H&R BLOCK

APPROVED PLAN
CITY OF PUYALLUP
PLANNING DIVISION

| Client: H&R BLOCK | Date: 12/2/22 | File Location: HRB-18004-Puyallup, WA R2 | Page No. |
| Site: Site # 18004 4227 S Meridian, Ste C Puyallup, WA 98373 | Designer: SO |  | 2 of 6 |

2 REFACE EXISTING TENANT PANELS
SCALE 1/2" = 1'-0"

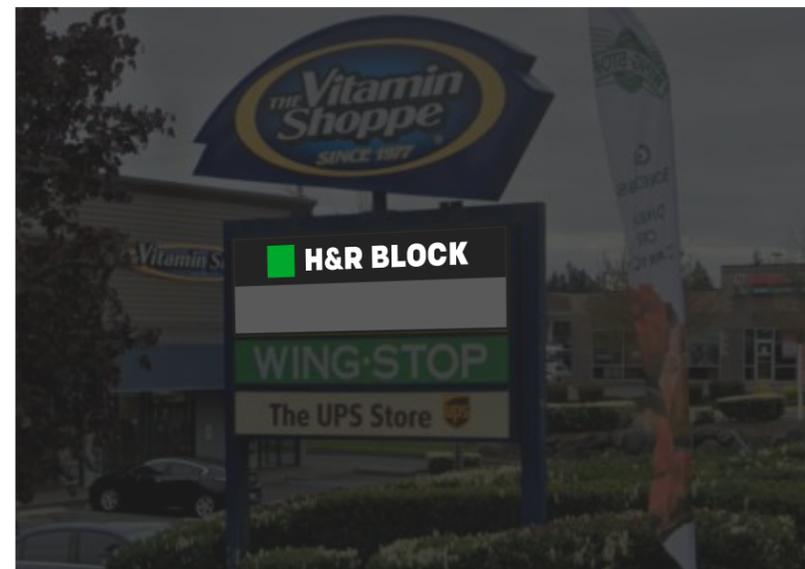
Not included in this Permit per PMC 20.60.025

TYPICAL SECTION DETAIL
SCALE 3/4" = 1'-0"

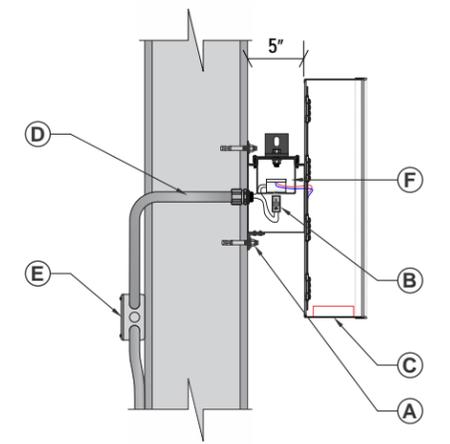
CUSTOM LETTERSET TO MEET CODE REQUIREMENTS
CITY REQUIRES 3/8" X 4" LAG BOLTS INTO WOOD STUDS - 4' ON CENTER
